IFB No. **IFB No. 22-49 Administration Building Lower-Level Renovations**

RE: **ADDENDUM NO. 2**

PROJECT: ADMINISTRATION BUILDING BASEMENT RENOVATION
ROCKFORD PUBLIC SCHOOLS 205
ROCKFORD, ILLINOIS

PROJECT NO.: RPS IFB 22-49, RPS PROJECT NO. 2112
LDG PROJECT 30186

DATE: 04-13-2022
PROJECT NUMBER: 30186
SHEET NUMBER: E1.1

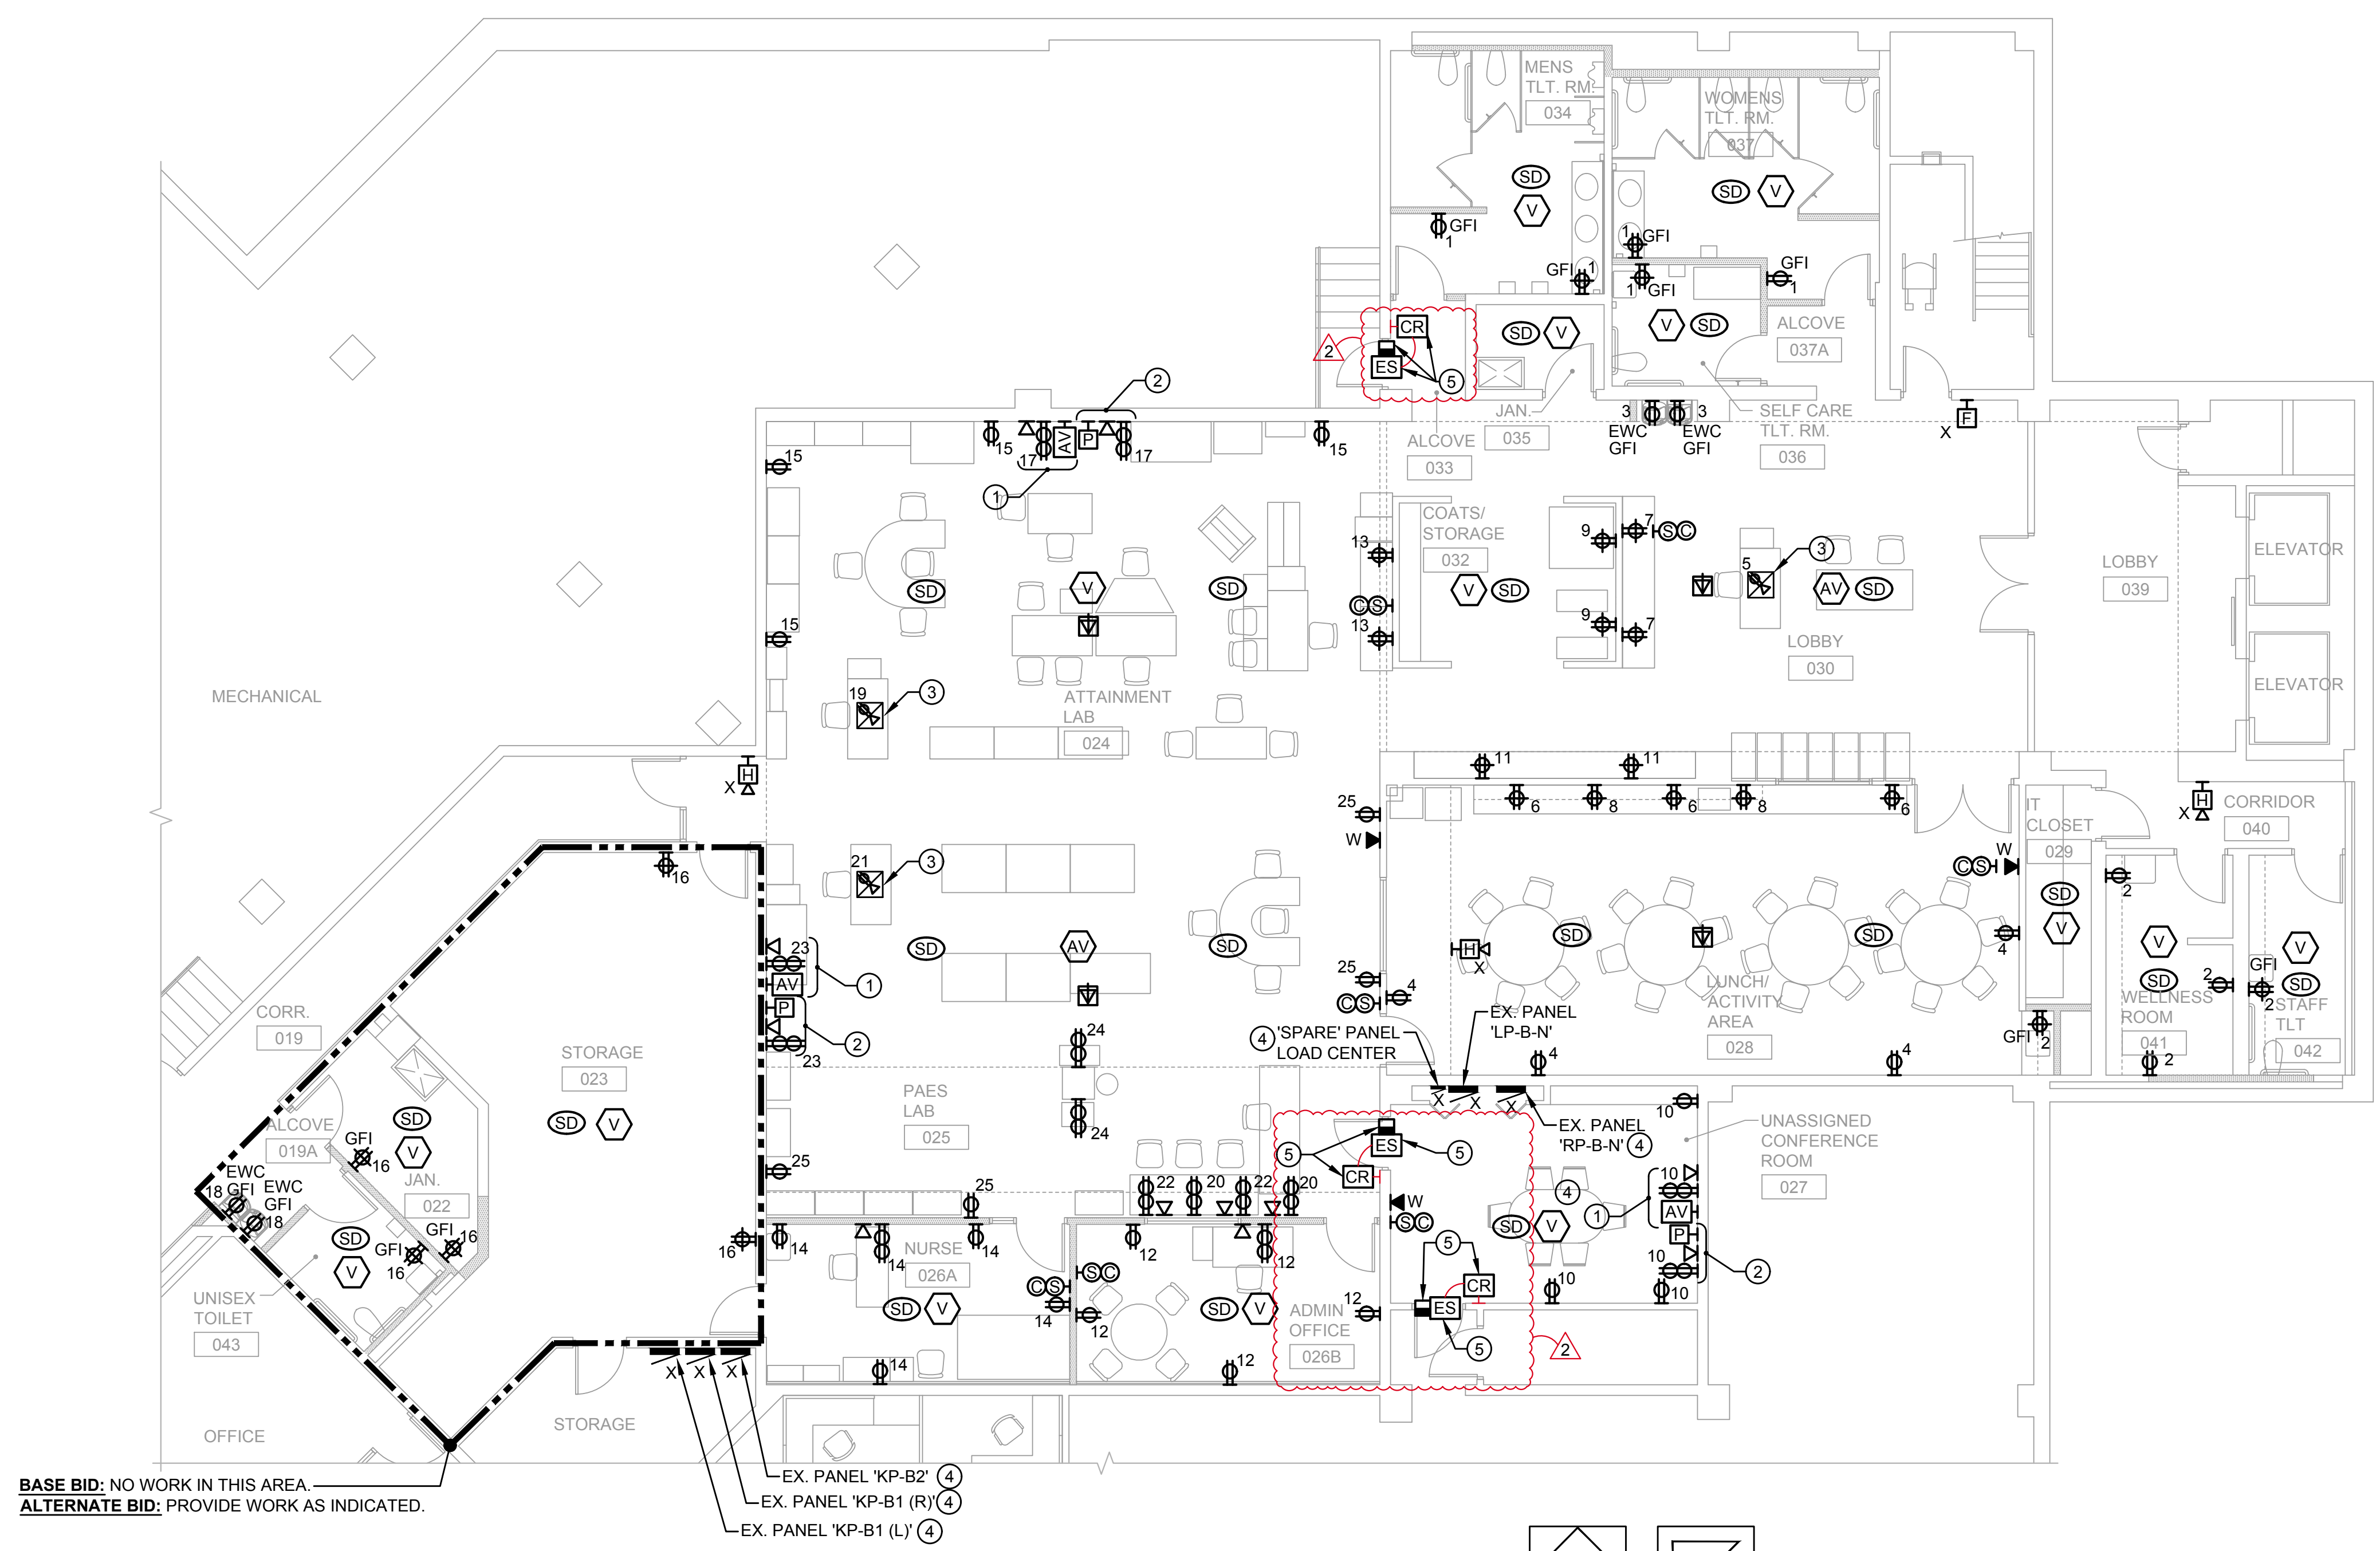
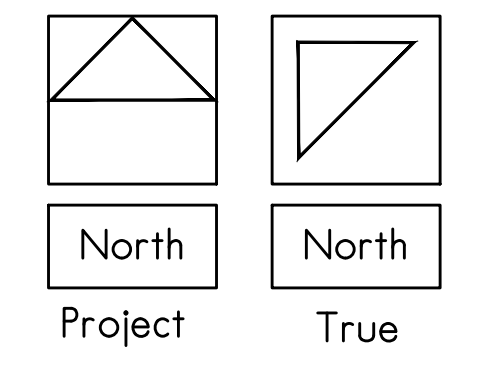
- A. Question: Drawing E1.1 shows new floor boxes. Can you provide the details of the floors construction, is there a raised floor that we will have access to run our conduits thru, is it concrete slab that will need to be cut and patched, if so who will be cutting/patching concrete floors? L&D Response: Existing floor is a concrete slab on grade. Cutting and patching shall be included in the Contract. Contractor to determine which trade performs cutting and patching.

- PROVIDE FLUSH FLOOR BOX WITH RECESSED OUTLETS. PROVIDE TWO (2) DUPLEX RECEPTACLES AND TWO (2) DATA JACKS. WIREMOLD RESOURCE RFB SERIES. PROVIDE WITH COVER TYPE TO MATCH FLOORING. COLOR SELECTION BY ARCHITECT. CONTRACTOR SHALL SAW CUT AND PATCH FLOOR AS REQUIRED. PROVIDE TWO (2) 1" CONDUITS FOR POWER AND DATA.

DATE: 04-13-2022
PROJECT NUMBER: 30186
SHEET NUMBER: E2.1

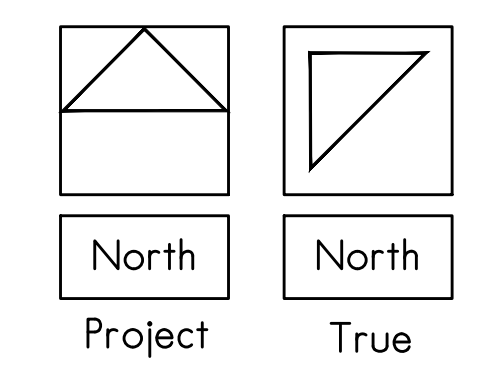
- C. Question: Can you please confirm the location to the first floor existing panel 'EM1-S1' for the emergency lighting circuits? This panel is called out on drawing E2.1 at the

bottom of the Device Symbols Legend, but I do not see if shown on the drawings. L&D Response: See revised Drawing E2.1, issued herewith.

HOMERUN ALL NORMAL LIGHTING BRANCH CIRCUITS TO EXISTING PANEL "LP-BN" AND EMERGENCY LIGHTING CIRCUITS TO EXISTING PANEL "EM1-S1" (ON FIRST FLOOR). CIRCUIT NUMBERS INDICATED ARE FOR REFERENCE PURPOSES ONLY IN ORDER TO INDICATE GROUPING.

APPROXIMATELY LOCATION OF PANEL "EM1-S-1" ON FIRST FLOOR
